City of Aurora Building Division
Reviewed for Code Compliance
Approved as Noted: *John Lichtner*
Date: Feb 24, 2017
2015 INTERNATIONAL CODES & 2014 NEC

A RENOVATION FOR MEDICAL CENTER I & II FOR HCP

1411 SOUTH POTOMAC
AURORA, CO 80012

City of Aurora Building Division
Project: **AURORA MEDICAL CENTER INT REM**
Address: **1411 S POTOMAC ST**
Occupancy Group: **B**
Construction Type: **II-B-SPK**
RSN: **1186837**
Permit: **17-1253295-LT**

NOTED
PLAN
A1.0-1

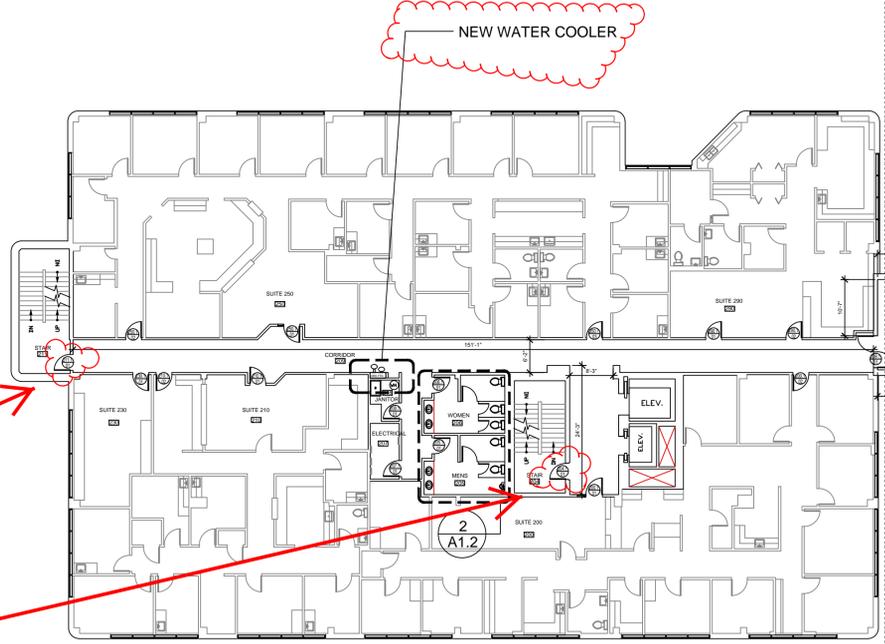
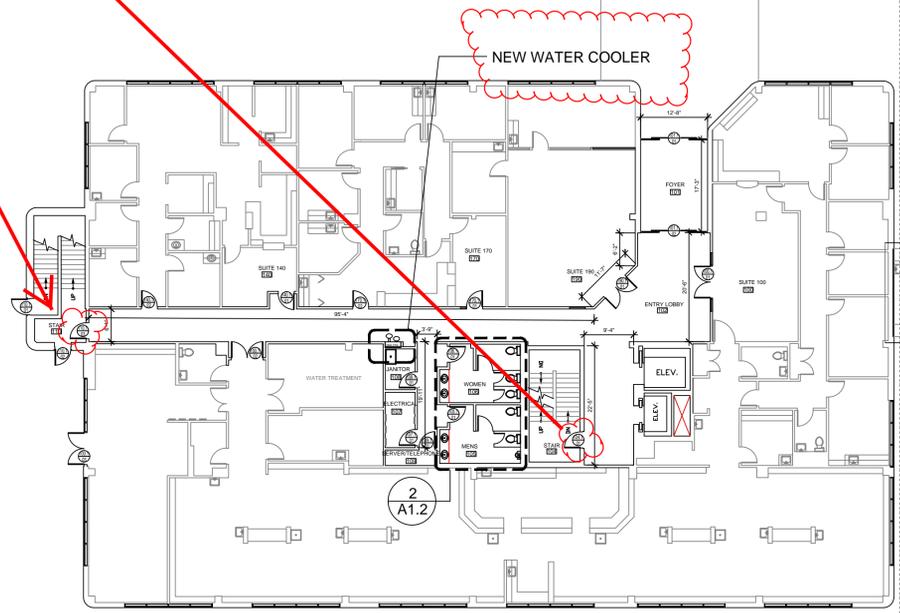
TYP ALL FLOORS THIS BUILDING HAS BEEN RECLASSIFIED AS AN IBC BUILDING. RATED CORRIDORS ARE NOT REQUIRED. IBC 1020

TYP. DOORS BETWEEN STAIR SHAFT AND INTERIOR SPACES ARE REQUIRED TO BE 90 MINUTE RATED DOORS. IBC 716.5
